ADDENDUM NO. 3

TO THE DRAWINGS AND SPECIFICATIONS
FOR THE
Burgin Independent School Addition & Renovation
Burgin, Kentucky
RTA 1904
BG 19-262
October 23, 2019

1904: BURGIN INDEPENDENT SCHOOL RENOVATION AND ADDITION
ADDENDUM # 3 - MEP **10/22/2019**

MANUFACTURER & MODEL: RATIONAL CM P 202G

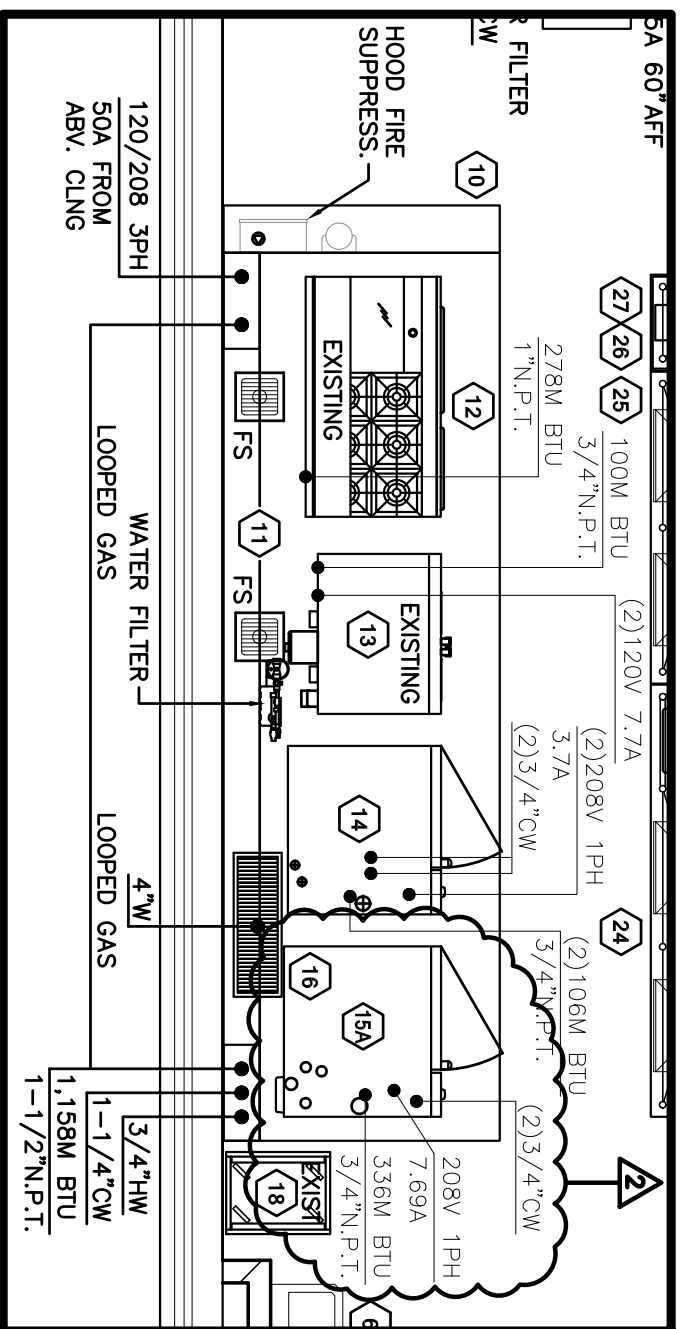
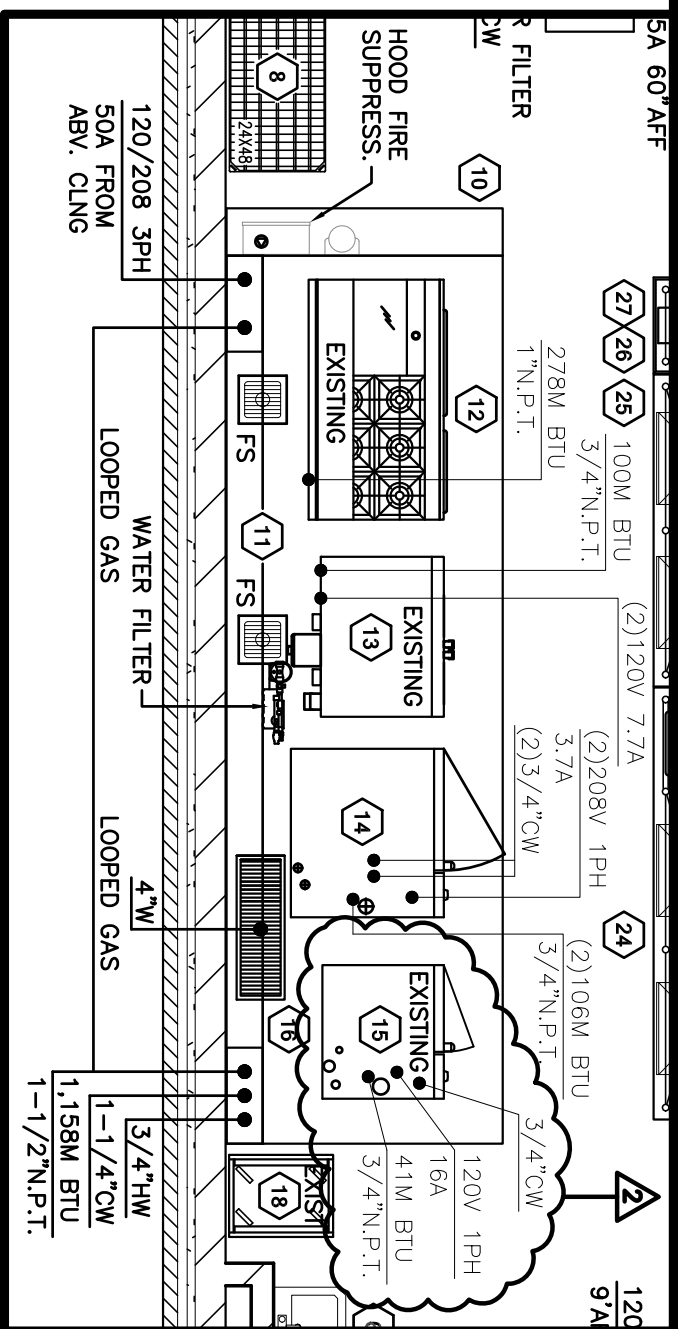
b) Revised:

ITEM 15 – COMBI OVEN – ROLL-IN – ONE (1) REQUIRED.

Changed to:

ITEM 15A – COMBI OVEN – ROLL-IN – ONE (1) ALTERNATE #8.

Provide roll-in model, natural gas CombiMaster PLUS on legs with adjustable feet. Oven to have 304 stainless steel interior and exterior, and include: right-hinged door with rear-ventilated double-glass, plug-in type door gasket, integral sealing mechanism for cooking cabinet, magnetic door switch with automatic shut-off when opened and restart when closed, seamless hygienic cooking cabinet with coved corners and splash guard, halogen illuminated cooking cabinet, Care Control system with automatic cleaning and descaling of steam generator, 7 cleaning stages for unsupervised overnight cleaning and care, reversing programmable 5 speed fan, integral fan impeller brake, safety temperature limiter, high-performance fresh steam generator, automatic active rinsing and drainage of steam generator by pump, CombiMaster PLUS control panel, individual programming of 100 cooking programs with up to 6 steps each, diagnostic system with automatic service notices, mode and alarm displays, HACCP data output and software update via integral USB Interface, manual cleaning program, integral maintenance free grease extraction system, cool down system, automatic adaptation to the installation location (elevation, climate, etc), swiveling service door for service and monitoring, retractable hand shower with automatic rewind, separate solenoid valves for fresh or soft water, menu-guided descaling program, demand related power supply by means of modulating, low-noise high-performance blower burner system, integral core temperature probe, mobile oven rack with tandem casters, and handle mount for mobile oven rack. Oven to be microprocessor controlled. 336,000 BTU 208/60/1
